MOONEY AIRCRAFT INC.
SERVICE LETTER 20-46

Subject: Inspection of Empennage Components

Models Affected: As noted below

Time of Compliance: To be accomplished immediately in conjunction with FAA telegraphic airworthiness directive, issued 4-22-59, concerning P/N 3009 (See Item 1 Below for Contents of A. D. Note)

See drawing of P/N 3449 below.

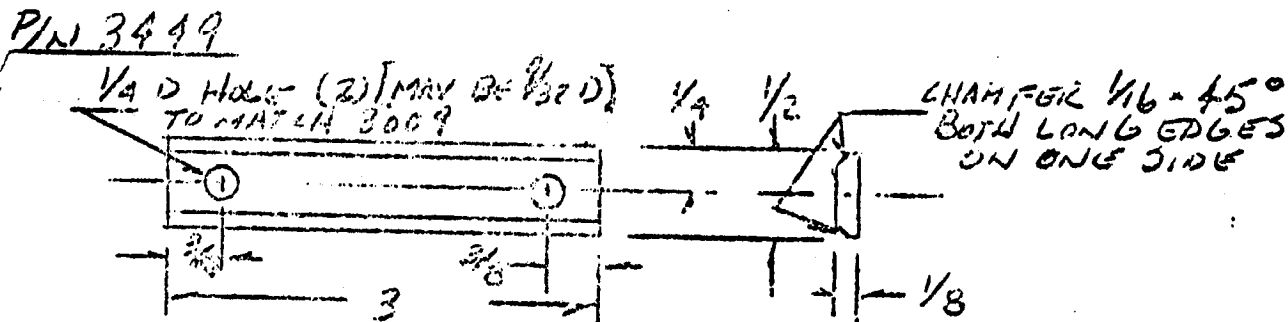
1. On M20 & M20A all Serial numbers remove and inspect immediately the empennage to fuselage upper attach bracket Part No. 3009 for cracks in bend radii near bolts. Remove paint and use dye penetrant and a ten power glass. Replace all cracked brackets and all brackets damaged by bolt head bearing in radius area of brackets with identical new brackets using 1/8 inch longer bolt, AN4-16A, and 1/8 inch by 1/2 inch by 3 inch -- 1010 cold rolled steel bearing plates Part No. 3449, under the heads of bolts attaching brackets Part No. 3009 to fuselage bulkheads. Bearing plates Part No. 3449 may be made using Part No. 3009 bracket to locate over-size 9/32 inch holes for attach bolts and by filing 1/16 inch by 45 degree chamfer along edges to provide clearance at radii of brackets. Drill and deburr bearing plates. All brackets found satisfactory may be reinstalled provided they are installed with AN4-16A bolts and the above bearing plates, Part No. 3449. Washers on airplanes Serial Numbers 1359 and up shall be replaced with bearing plates.
